Duane Arnold Energy Center  
Docket No. 50-331  
Renewed Op. License No. DPR-49

Response to Request for Additional Information, License Amendment Request (TSCR-159) to Revise Technical Specifications Fuel Storage Requirements – MF7486

Response to Request for Additional Information, License Amendment Request  
(TSCR-159) to Revise Technical Specifications Fuel Storage Requirements

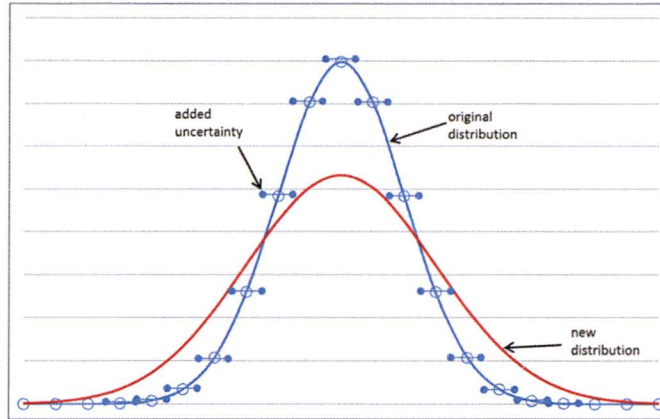
- a. Provide the basis for the conclusion that the BADGER tests results that fell below the minimum  $^{10}\text{B}$  AD are solely due to uncertainties, given that the uncertainty identified in the LAR (0.0012 grams  $^{10}\text{B}/\text{cm}^2$ ) is less than the difference (0.0027 grams  $^{10}\text{B}/\text{cm}^2$ ) between the BADGER measured  $^{10}\text{B}$  AD (0.0205 grams  $^{10}\text{B}/\text{cm}^2$ ) and the certified minimum  $^{10}\text{B}$  AD (0.0232 grams  $^{10}\text{B}/\text{cm}^2$ ), as reported in the LER.

Statistics support the conclusion that the measurement uncertainty added by BADGER is the most likely cause. The results of the DAEC BADGER measurements documented in Revision 2 of the vendor report show the 60 panels measured had an average areal density of 0.0252 grams  $^{10}\text{B}/\text{cm}^2$  and a standard deviation of 0.0016 grams  $^{10}\text{B}/\text{cm}^2$ . The population average areal density is close to the nominal areal density of 0.0250 grams  $^{10}\text{B}/\text{cm}^2$ , yet the population standard deviation leads to an uncertainty of 0.0033 grams  $^{10}\text{B}/\text{cm}^2$ , much larger than the initial as-built uncertainty of 0.0018 grams  $^{10}\text{B}/\text{cm}^2$ . When adding an uncertainty to a population, the resulting population will have the same average value, yet the new standard deviation will be the square root of the sum of the squares of the original and added standard deviations [ $\sigma_{\text{new}} = (\sigma_{\text{orig}}^2 + \sigma_{\text{add}}^2)^{1/2}$ ]. The sketch below provides a pictorial representation of adding uncertainty to a distribution.

To account for the added measurement uncertainty, the new analysis documented in the LAR (Reference 1) does not use an uncertainty of 0.0012 grams  $^{10}\text{B}/\text{cm}^2$ . Instead, the new analysis uses a minimum areal density of 0.0150 grams  $^{10}\text{B}/\text{cm}^2$ , so the equivalent uncertainty, based on the nominal value of 0.0250 grams  $^{10}\text{B}/\text{cm}^2$ , is essentially increased from 0.0018 grams  $^{10}\text{B}/\text{cm}^2$  to 0.0100 grams  $^{10}\text{B}/\text{cm}^2$ . The uncertainty of 0.0012 grams  $^{10}\text{B}/\text{cm}^2$  is only applicable to the analysis for the Holtec racks.
